DA 2010/0770 Cycle Park, Lot 20 DP 1119593, Vale Road (MR 54) Bathurst

Roads and Traffic Authority of New South Wales

Figure 7.7: Channelised right turn (CHR) on a two-lane rural road

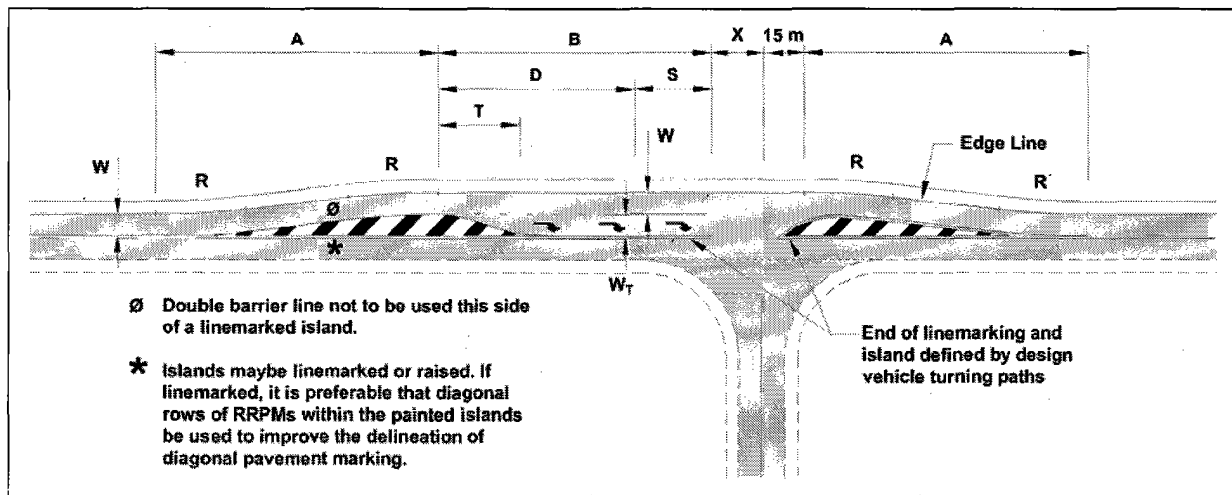
- A right turn treatment of the 'Type CHR' (Channelised Right Turn) is to be constructed adjacent to the southbound lane on Vale Road as per Fig 7.7 in the *Austroads Guide to Road Design: Part 4A*. A copy is provided for your information.
